**Modification sheet No. RDSO/2014/EL/MS/0436 (Rev.0), Dated 11.07.2014**

Modification to address failures of DC link capacitors of 3x100 kVA, GTO based auxiliary converter.

Fig.1

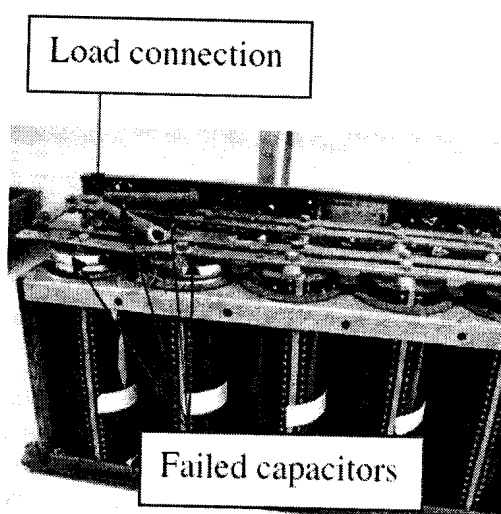
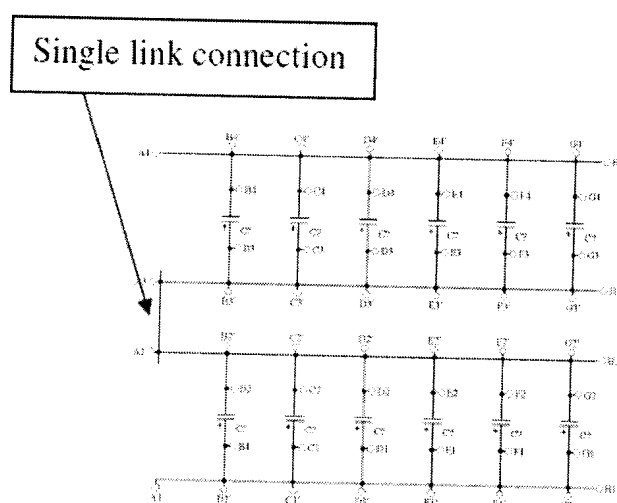
**Existing Design:** In most cases, it has been observed that failure is initiated from the load side as shown in Fig1. This is attributed to higher loading of capacitors near the load connections. The reason for this load imbalance is that the two parallel banks of capacitors are linked to each other via just a single link as shown in Fig2.

**Modified Design:** As shown in Fig. 1 & 2, two parallel banks of capacitors shall be linked with a number of links individually instead of a single link in order to achieve better load sharing. Further, the load connections shall be connected to the center of the capacitor banks shown in fig.3 & 4 as A1 and A2.

Fig.5

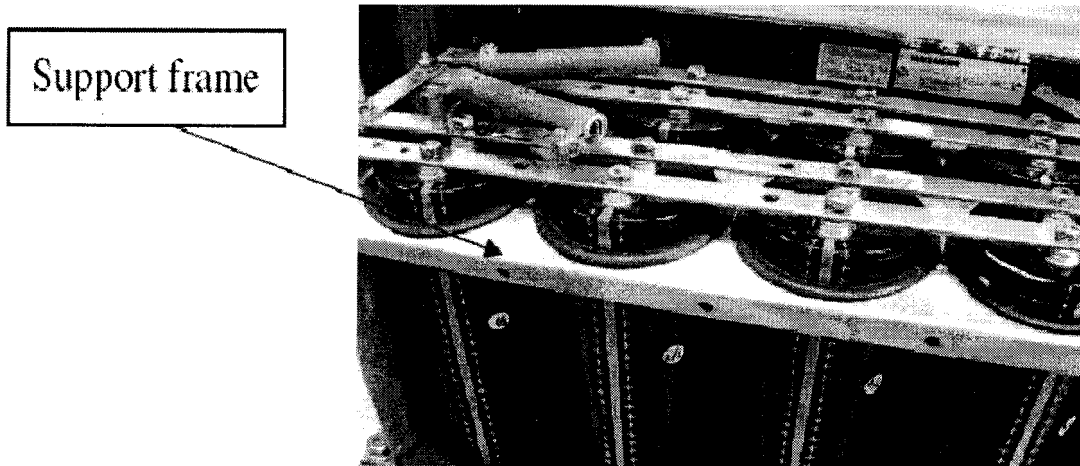
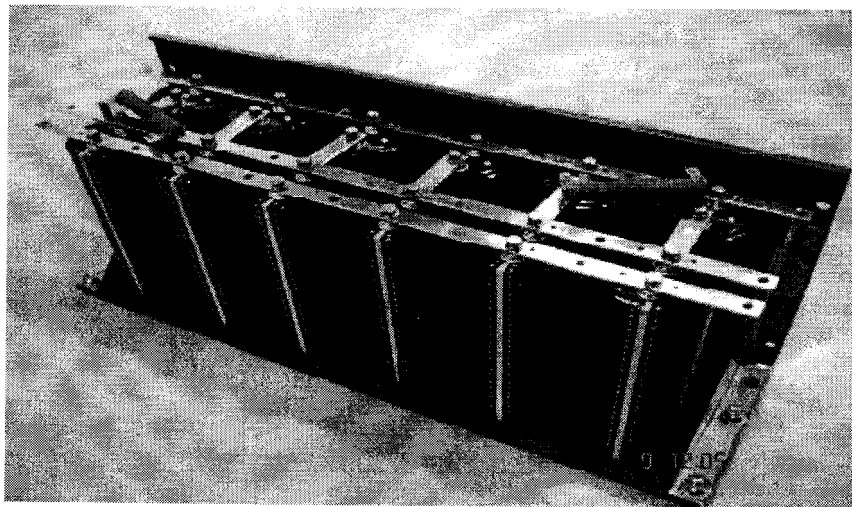
**Existing Design:** As seen in Fig.5, the presence of the support frame around capacitor bank restricts the air flow between the capacitors and therefore capacitors are more prone to get heated up.

**Modified Design:** Frame arrangement shall be removed as shown in Fig.6 which allows better air circulation between the capacitors.

Fig.8

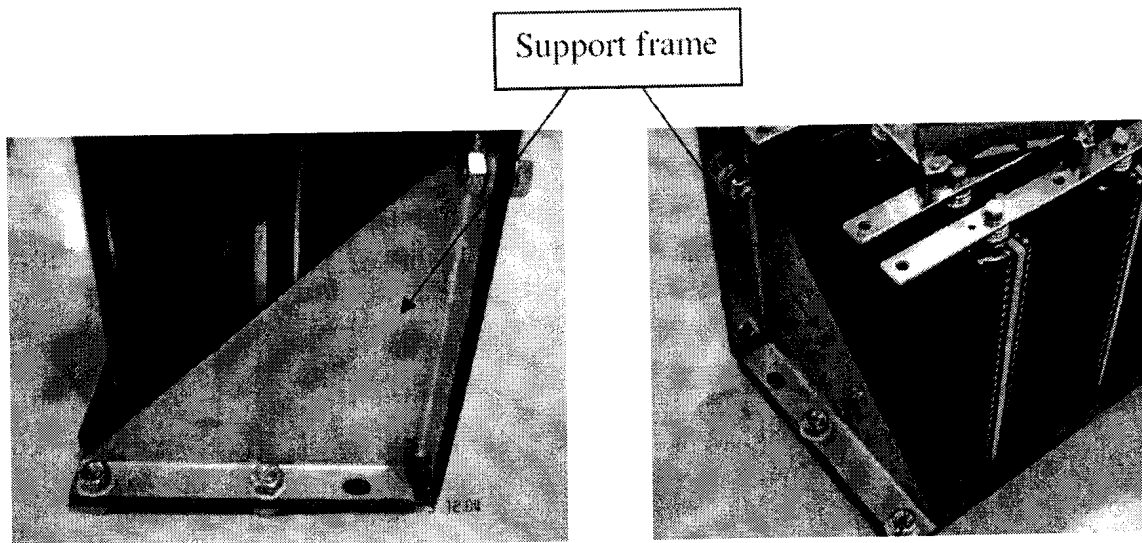
- 3.3 Tightening torque of capacitor terminals shall be increased from 3.5 Nm to 6.0 Nm; and**
- 3.4 Provision of side mechanical support to improve stability**

Support clamps of material SS304 of 1.5 mm thickness are required to be added at both the sides of capacitor bank in order to provide mechanical stability as shown in fig. 8 & 9.

**Material:** SS304

**Thickness:** 1.5 mm
